**100 Eton Road, Lindfield NSW**

LINDFIELD LEARNING VILLAGE

**ROOF & FAÇADE BUSHFIRE MEASURES CONFORMANCE REPORT**

REPORT 2018/321 R3.4

## APPENDIX B. ZONE A PHOTOGRAPHS

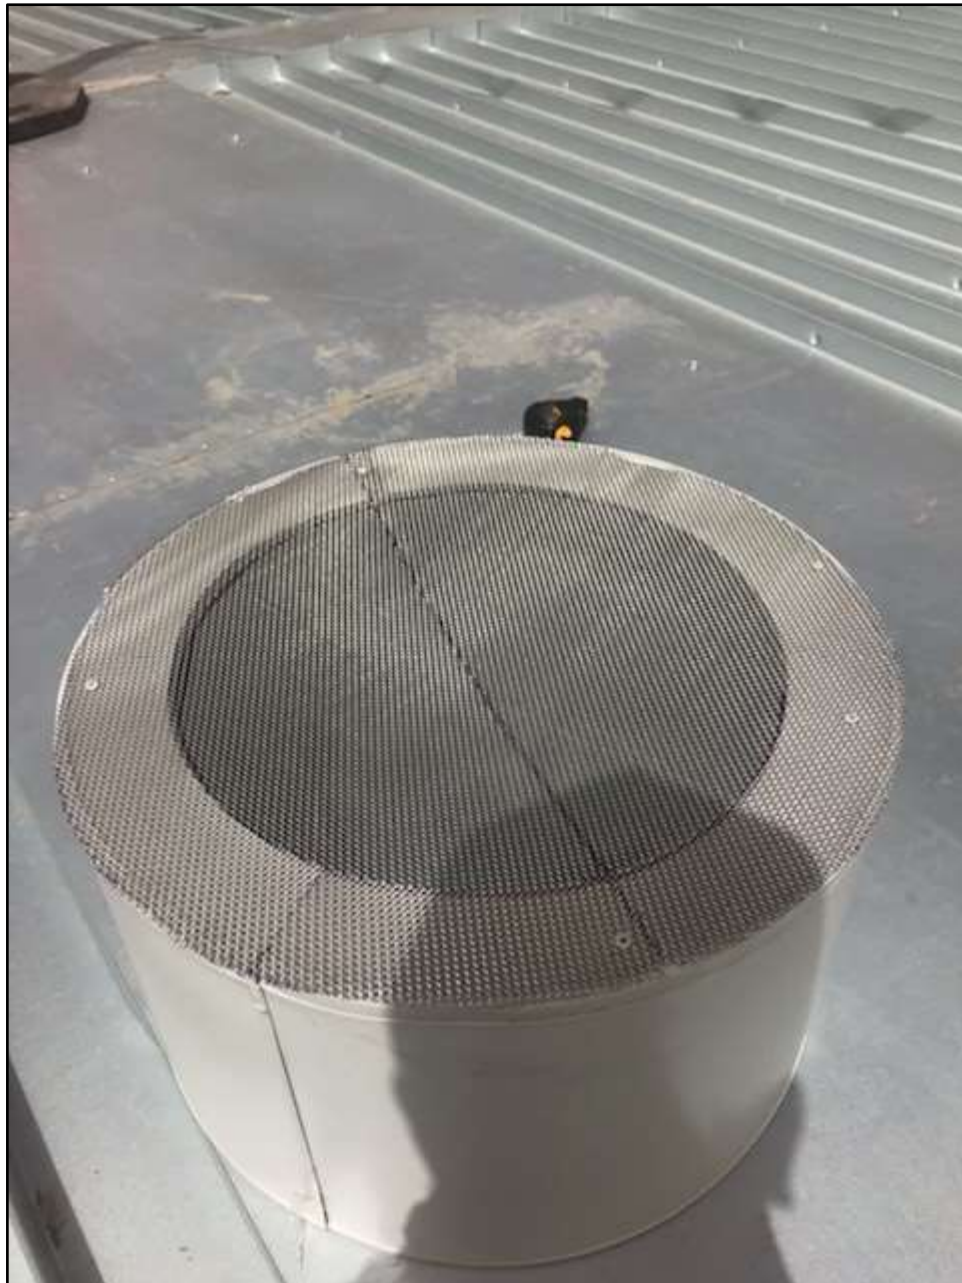
14. Roof Penetrations	Certificate by the Bluewater Group NSW regarding roof penetration fire seals	Level 7 (Roof Level) could not be accessed at the time of inspection.	Conforms, subject to the following: <ul style="list-style-type: none"> <li>Photographic evidence showing that the fume cupboard extraction pipework (potentially PVC material) has been enclosed with non-combustible material as a minimum requirement; and</li> <li>Photographic evidence showing that the pipework penetrating Level 6 southern balcony has been covered with a dome.</li> </ul> The above items were confirmed as rectified through photographic evidence received on 13 <sup>th</sup> and 14 <sup>th</sup> February 2019. Refer to Appendix B for photographs of the pipework rectification work.
